DATE: January 18, 1972

SUBJECT: Control Surface Bearing Support Inspection

SERIALS AFFECTED: AA1A-0095 thru AA1A-0158, AA1A-0160 thru AA1A-0215, AA1A-0217 thru AA1A-0250, AA1A-0253 thru AA1A-0272, AA1A-0274, AA1A-0276 thru AA1A-0290, AA1A-0292 thru AA1A-0294, AA1A-0296 thru AA1A-0299, AA1A-0301, AA1A-0304 thru AA1A-0307, AA1A-0309, AA1A-0314, AA1A-0318 and AA1A-0320 thru AA1A-0323.

**FIGURE 1.**

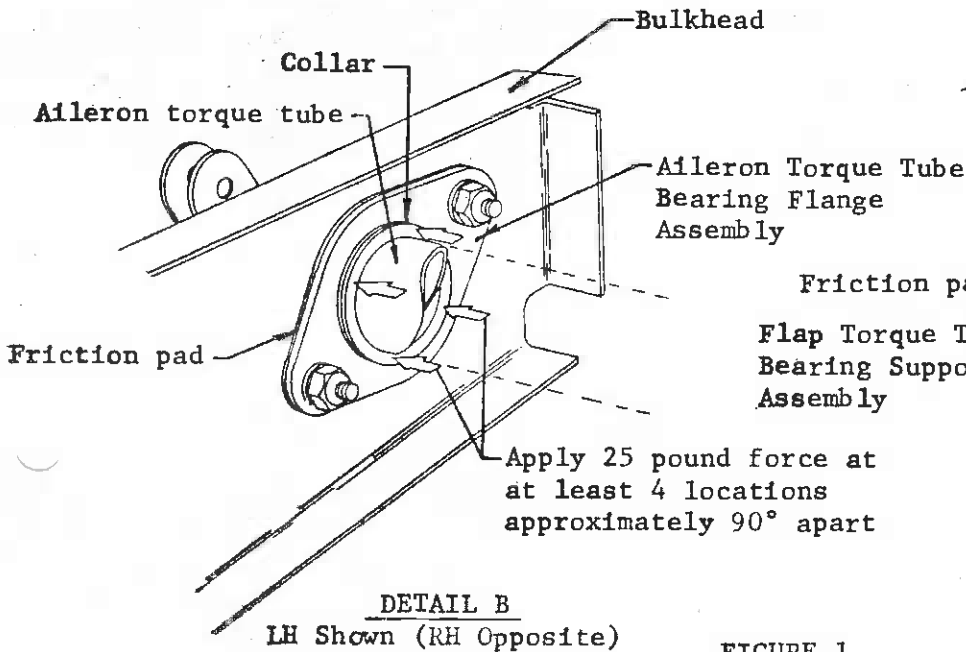
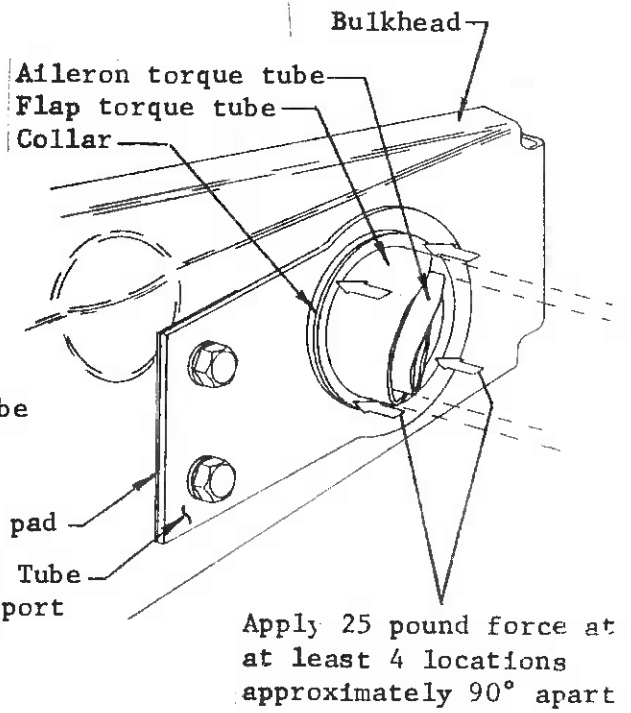
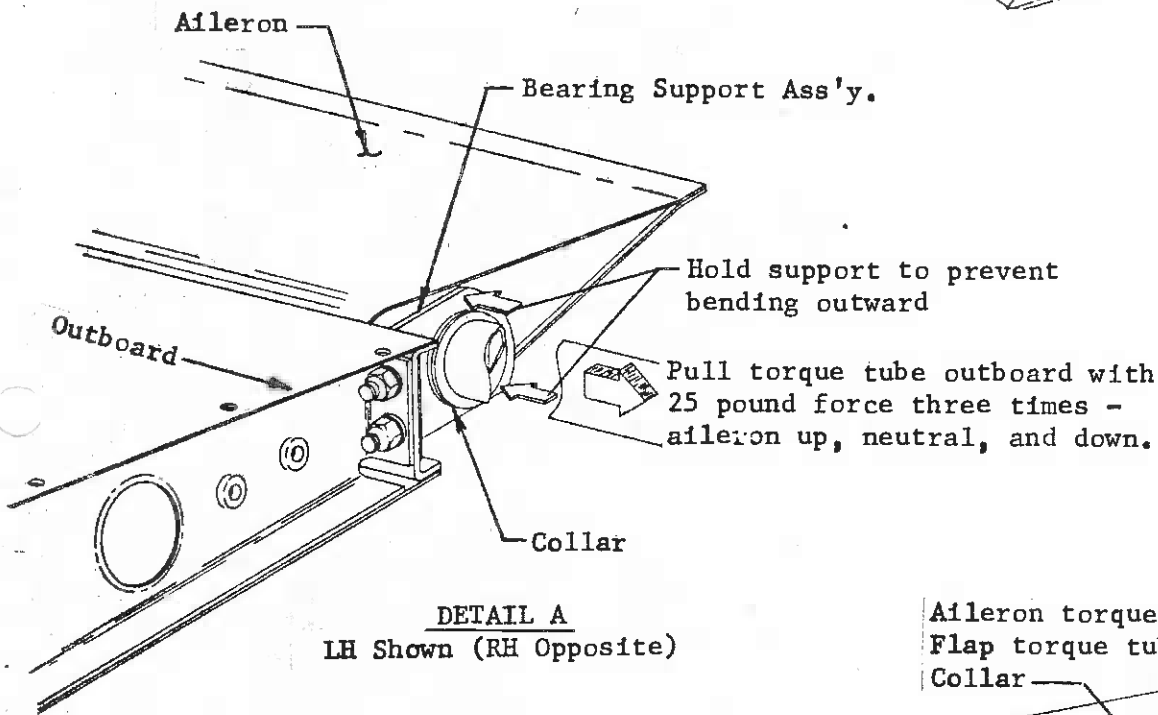
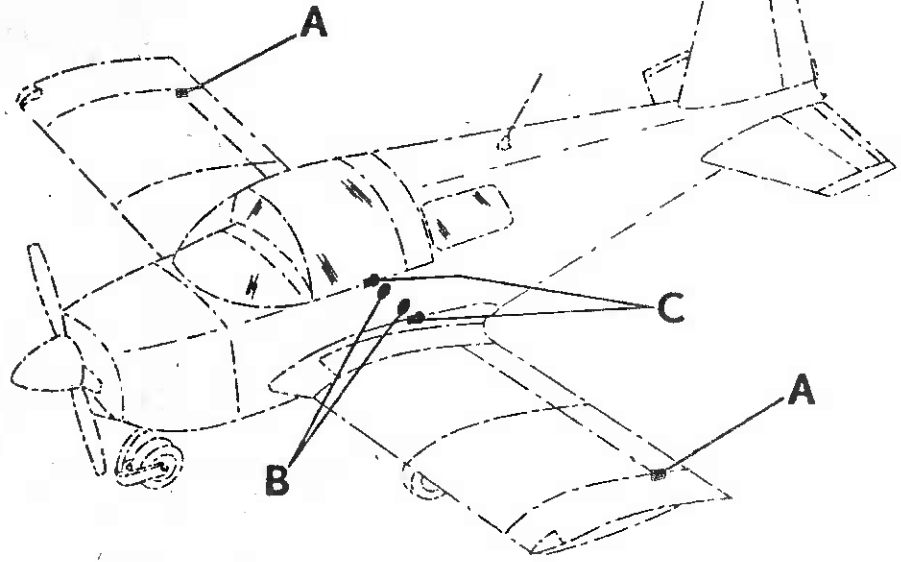
Inspection Procedure - Aileron Outboard Bearing Support (Ref. Figure 1, Detail A)

1. Remove wing tips. Hold bearing support to prevent bending outward. Grasp aileron torque tube and pull outboard with a 25 pound force. Apply force three times - aileron up, neutral and down.
2. Any visible movement between collar and support is cause for rejection and rework or replacement of the support assembly.

Inspection Procedure - Inboard Flap Torque Tube and Aileron Torque Tube Bearing Support/Flange Inspection (Ref. Figure 1, Detail B and C)

1. Lift up baggage floor covering and remove inspection covers.
2. Locate bearing support/flange assemblies. Apply 25 lbs. of force at approximately each 90° around the collar circumference using the extremes allowed by raising and lowering the flaps and ailerons.
3. Any visible movement between collar and support/flange is cause for rejection and rework or replacement of the support/flange assembly.

It is further recommended that all control surface bearing support assemblies be inspected for security of the bearing retaining collar at the next 100 hour or annual inspection. If loose retaining collars are found, the bearing support/flange assembly should be removed and reworked per rework instructions listed below or replaced.

Figure 2.

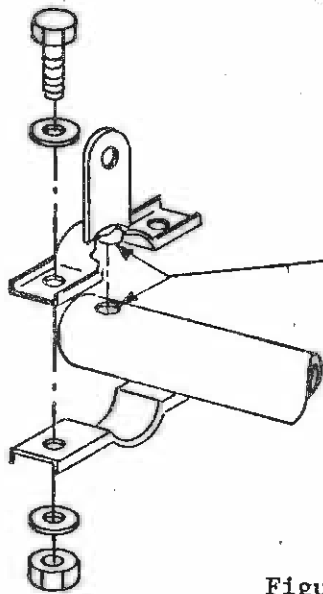
Installation of Inboard Flap Torque Tube Bearing Support Assembly (Ref. Figure 1, Detail C)

1. Complete all steps shown above under installation of inboard aileron bearing/flange assembly except do not remove flange assembly from bulkhead.
2. Disconnect flap bellcrank from flap torque tube.
3. Detach bearing support assembly from bulkhead, noting location of friction pad between support assembly and bulkhead and slide support assembly off torque tube.
4. Reassemble in reverse order noting that friction pad must be installed between bearing support assembly and bulkhead and that bearing support assembly location must be adjusted so that flap torque tube is concentrically located around aileron torque tube.

When installing the flap bellcrank horn, be sure the pin is engaged in the flap torque tube hole. This is essential for proper flap operation and rigging.

**FIGURE 3.**

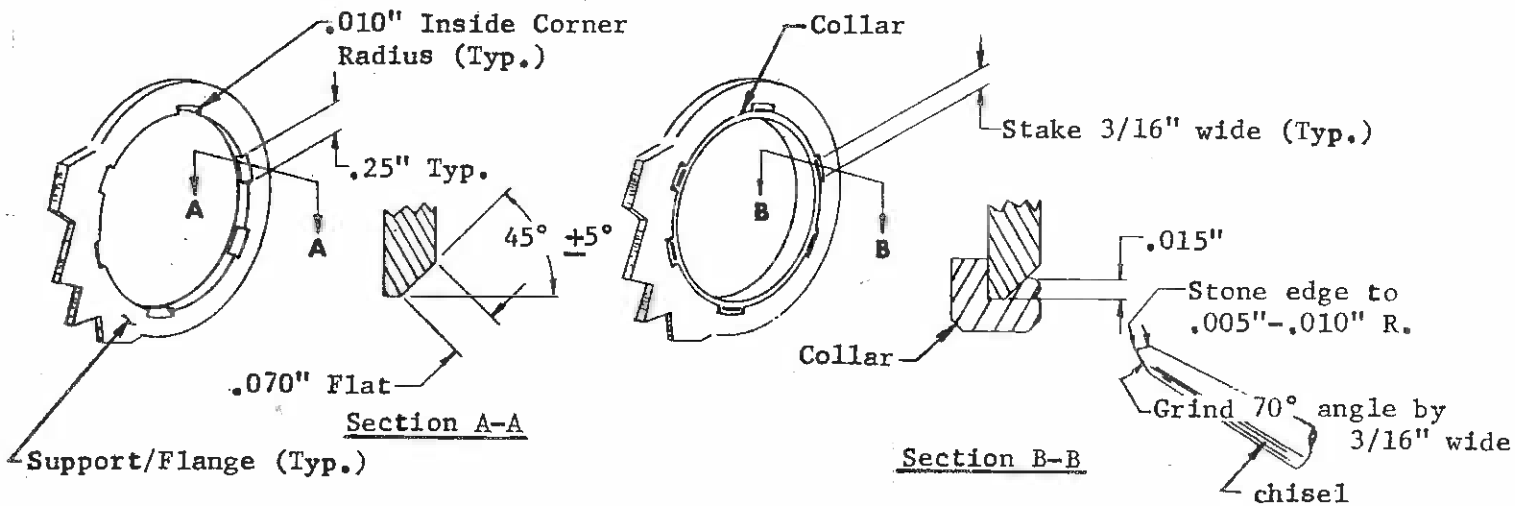
Defective bearing support/flange assemblies may be satisfactorily reworked in the field by removing the assembly from the aircraft, and modifying per step 1 and step 2 of Figure 3 below:

Step 1. File 6 flats .25" wide on chamfer side of support/flange

Step 2. Install collar and stake 6 places 3/16" wide

After rework, before installing the bearing support/flange assembly, determine that bronze/teflon bearing liner is in satisfactory condition. If bearing liner has been removed, it must be sized out round after installation in the collar. Bearing liner inside diameter may be lightly lubricated with Grease per MIL-G-7711.
